CAISO 2012/13 Transmission Plan

February 11, 2013 Stakeholder Meeting Comments

Submitted by	Company	Date Submitted
Dave Schiada Karen Shea Dana Cabbell Jorge Chacon	Southern California Edison	February 25, 2013

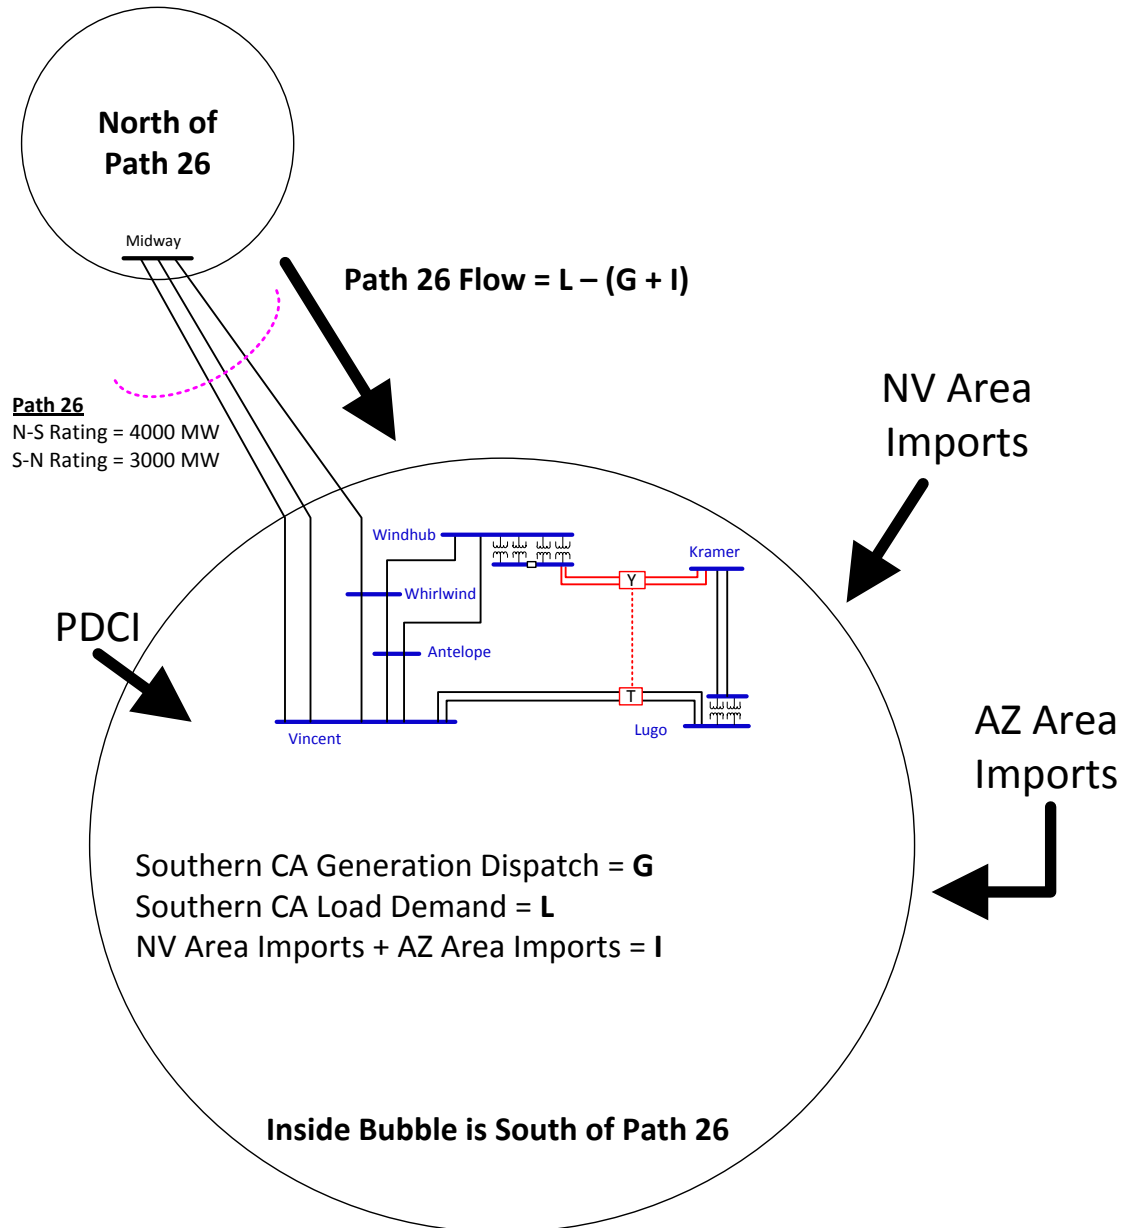
Response: The current system in place is adequate to support all existing load demand and installed generation. In particular, SCE address the following three areas: VAR support, Path 26 congestion relief, and N-2 contingencies in the Kramer area.
